SUBJECT: Single Phase, 4800 V Distribution line  
replacement.

Reference No: 06212551/Chase Twp/Lake/Lyonnais

**FIELD REVIEW FOR**  
**COMPATIBLE USE OF RIGHT-OF-WAY**  
Request # CU-154

July 1, 2005

Tower # 4021

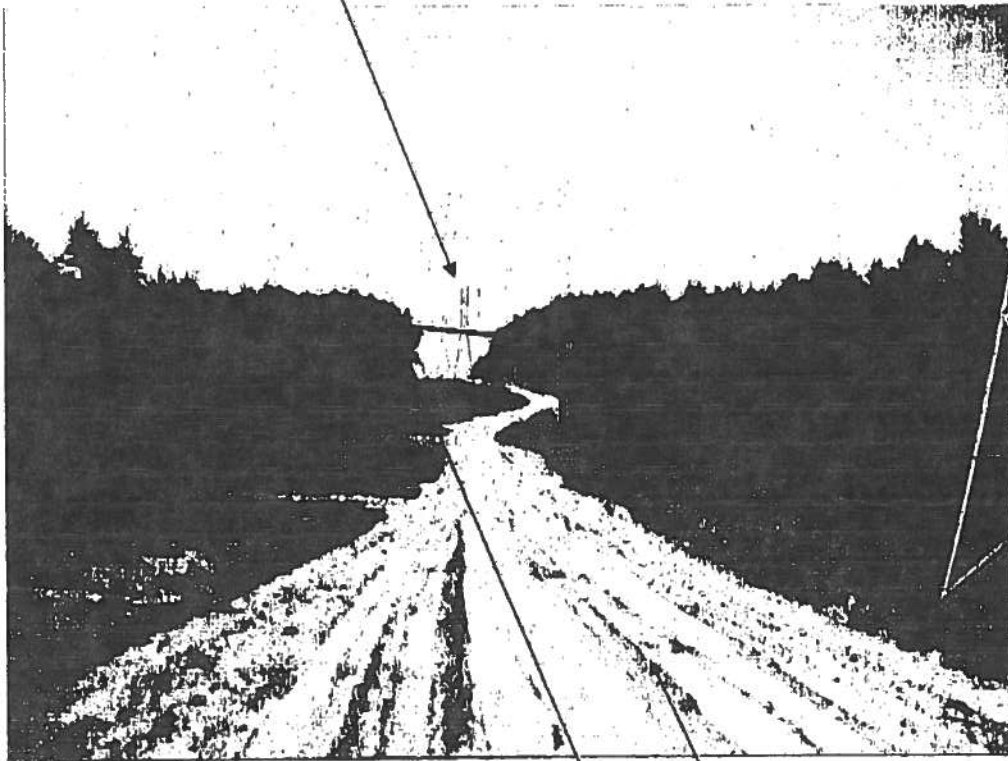
The proposed distribution line will be no closer than 37' from the centerline of the existing transmission line. The resulting horizontal clearance under a 6 psf wind is approximately 24'. NESC code (and CE Standards) requires a minimum of 3.5' between a 138 kV line and a distribution pole.

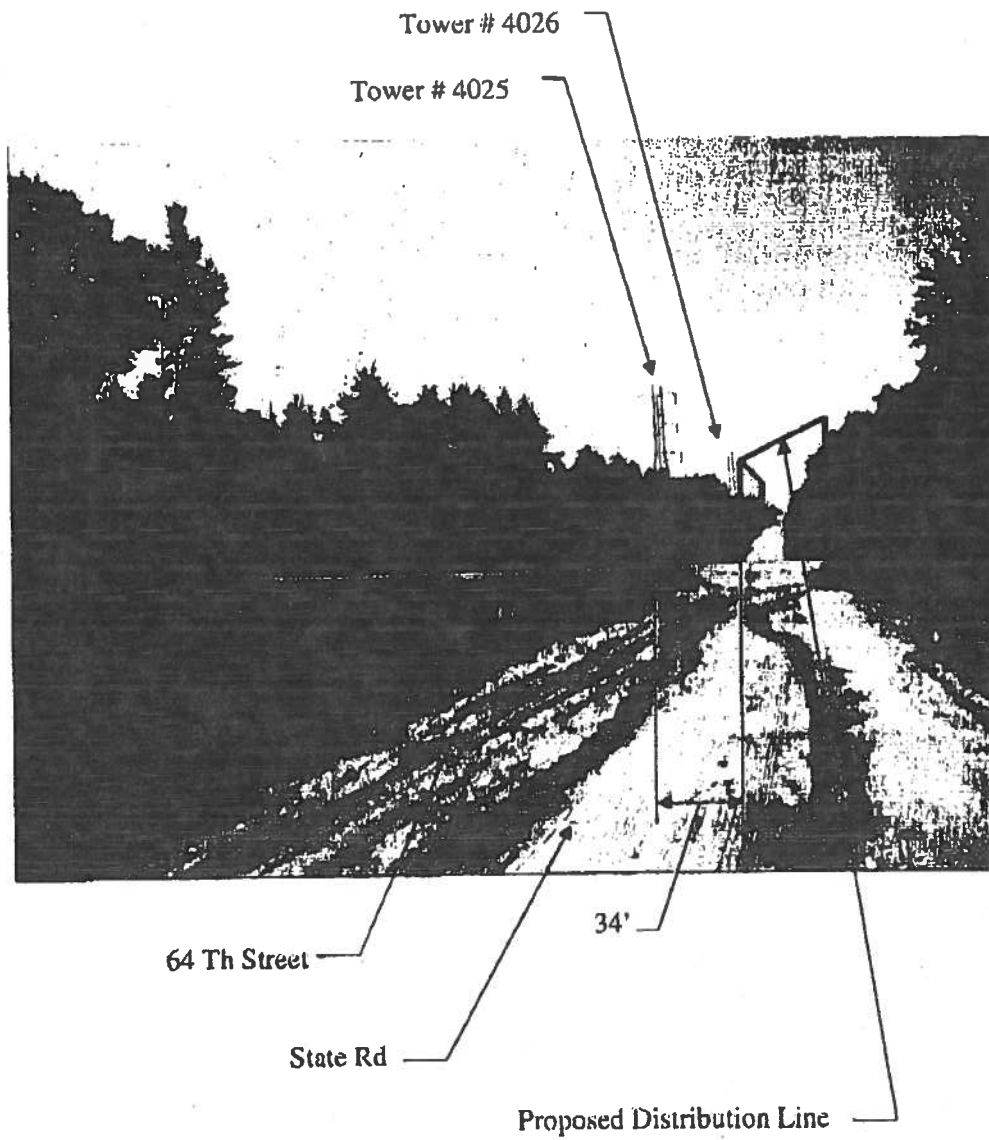
On the existing plan & profile drawing from CE, the existing 110 KCMIL copper conductor was plotted at 284° F. The pole height and class was provided by CE as being 40/6 poles. Using a typical embedment of 10% + 2' the distribution height is assumed to be at 34'. The resulting vertical clearance between the proposed distribution line and the existing conductor is approximately 3'. NESC code (and CE Standards) requires a minimum of 4.1' between a 138 kV line and a distribution line. See enclosed sketch.

Based on our field review and calculations, it is our recommendation that this line is not acceptable at this time in the proposed location.
